CONSTRUCTION SUMMARY

Summer Ridge Estates Inc.

LOT NUMBER	PHASE	HOUSE TYPE	CLOSING DATE
001 BLOCK 289	1	ROSE WATER (25-05 A O) ELEV A OPT	04-Nov-25

Invoice Number: 8782

LOWER LEVEL
ELEV.A

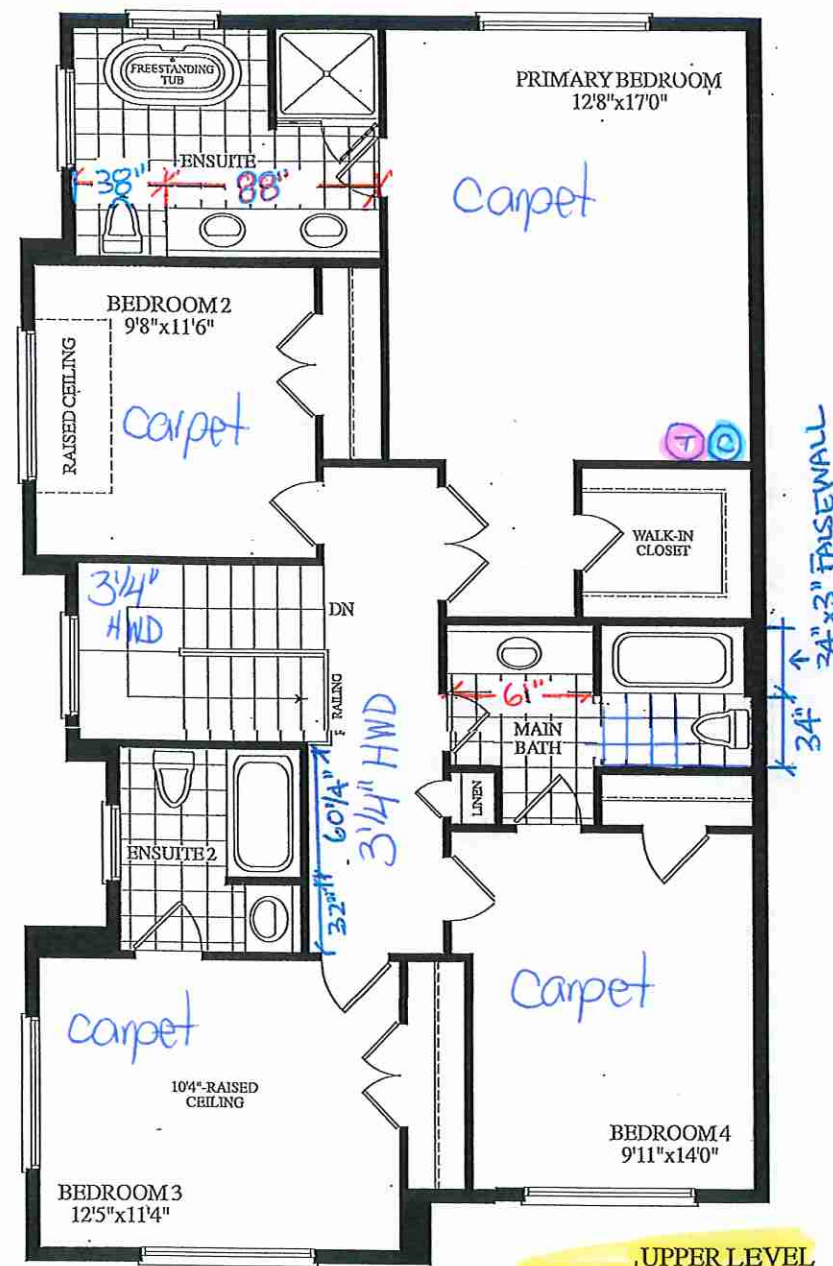
1 - Install Standard Cable Rough-Ins (x2) and Install Standard Telephone Rough-Ins (x2) (See Sketch) Note:
1 - MAIN FLOOR & 2ND FLOOR - BASEBOARD & CASING - Install UPGRADE #1 Baseboard & Casing - 3 1/2" Step Bevel Casig with 5 1/2" Step Bevel Basboard - To be installed throughout main floor and 2nd floor, where applicable (See Sketch) Note:
1 - CLARIFICATION; EXTERIOR - GARAGE DOOR - Install STANDARD Exterior Handle with Lock on Garage Door Note:
1 - MAIN FLOOR & UPPER HALL - FLOORING - HARDWOOD - Install prefinished 3 1/4" x 3/4" VINTAGE RED OAK BARISTA (Character Pearl) in lieu of builders standard prefinished 3 1/4" x 3/4" Vintage RedOak Natural Hardwood. Note: To be installed throughout main floor & upper hall, where applicable. To Include; Family Room, LivingRoom / DiningRoom, Upper Hall and Applicalbe Landings (See Sketch)
1 - STAIRCASE - Stain Oak Staircase from Main Floor to Second Floor, where applicable. To be Stained - Vintage Red Oak BARISTA - To Include; Treads, Risers, Handrail and Post, where applicable (See Sketch) Note:

KITCHEN PLAN

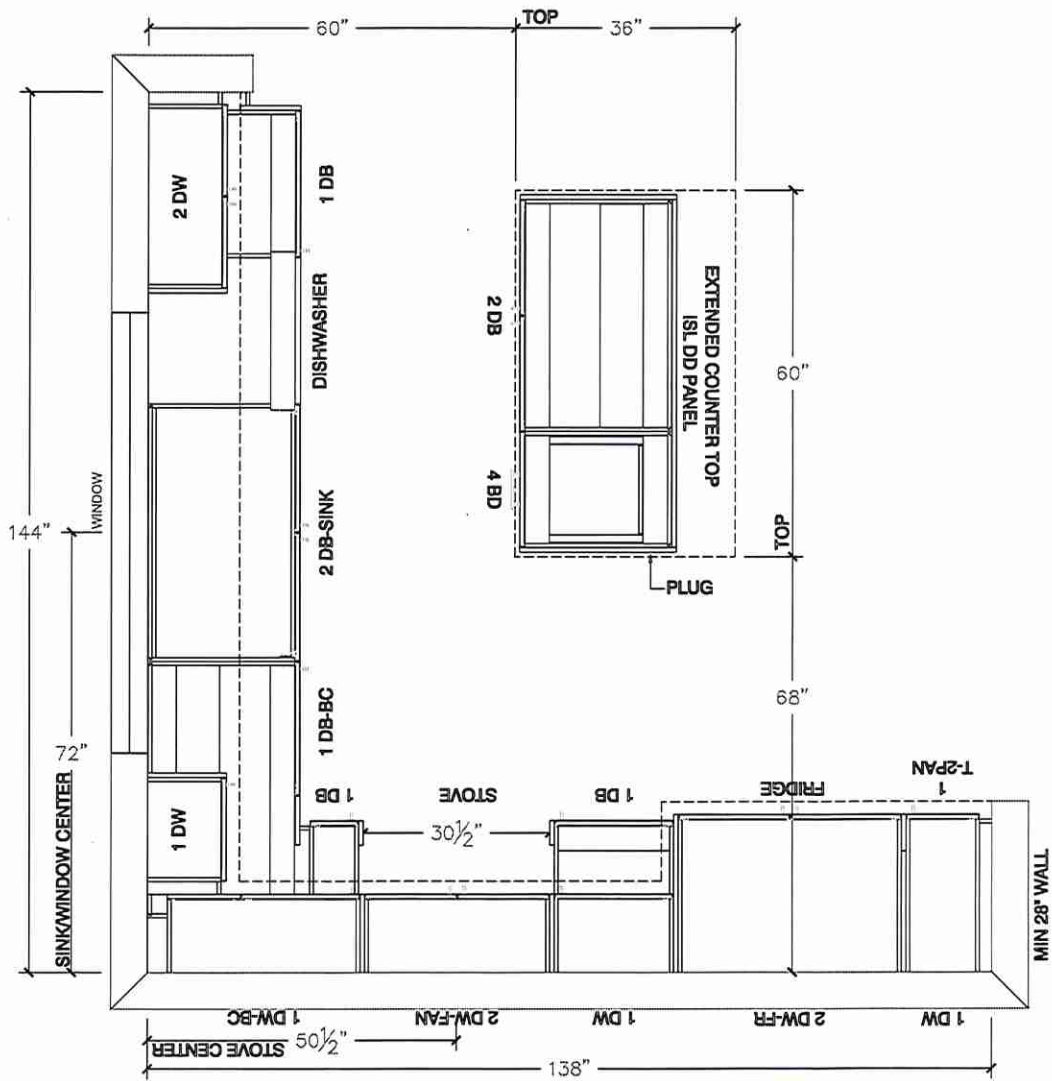
1 - KITCHEN - COUNTERTOP - Install UPGRADE #4 Stone Countertop – EVEREST NERO - To be installed throughout kitchen, where applicable (does not include stone backsplash) (See Sketch) Note:
1 - KITCHEN - COUNTERTOP EDGE - Install UPGRADE " L" EDGE PROFILE - To be installed throughout kitchen countertop, where applicable (See Sketch) Note:
1 - DISCLAIMER - STONE COUNTERTOP KITCHEN - Due to the many variables that can affect the pattern, colour and/or design and “pitting” of stone products, stone installed will not be identical to the samples displayed. Note: Every effort is made to provide stone countertops as close as possible but the vendor is not responsible for results which differ from the sample displayed. All countertop surfaces may have seams, and product pattern and shade can change in areas containing seams.
1 - DISCLAIMER - STONE COUNTERTOP KITCHEN - Stone slabs vary in size & all seams are visible & the fabricator reserves the right to position the seams as necessary. Note:

1 - KITCHEN - Install UPGRADE GAS LINE ROUGH-IN TO STOVE **(Includes Additional Applicable Electrical)** at kitchen (See Sketch) Note: **Purchaser Accepts & Acknowledges Appliance Specifications for GAS Stove are to be provided to decor centre during decor appointment**
1 - BONUS PACKAGE - PURCHASER HAS APPLIED \$10,000.00 (Includes Taxes) WORTH OF UPGRADE PROMOTIONAL PACKAGE TOWARDS THE PURCHASE OF STRUCTURAL UPGRADES COMPLETED AT THE DECOR CENTRE Note: **Remaining Bonus Package of \$8,305.00 (Includes Taxes) will be applied to upgrades completed during decor appointment**
1 - PURCHASER HAS ATTENDED A STRUCTURAL APPOINTMENT AT THE DESIGN STUDIO & HAS DECLINED ANY ADDITIONAL UPGRADES. Purchaser accepts & acknowledges that there will be no further structural changes/additions/deletions to be made upon signing on MARCH 11,2025 Note:
1 - PURCHASER AWARE AND ACCEPTS THAT ANY CHANGES MADE TO UPGRADES AFTER SIGNING THIS PURCHASERS EXTRA FORM ARE SUBJECT TO A MINIMUM ADMINISTRATION FEE OF \$1,000 Note:
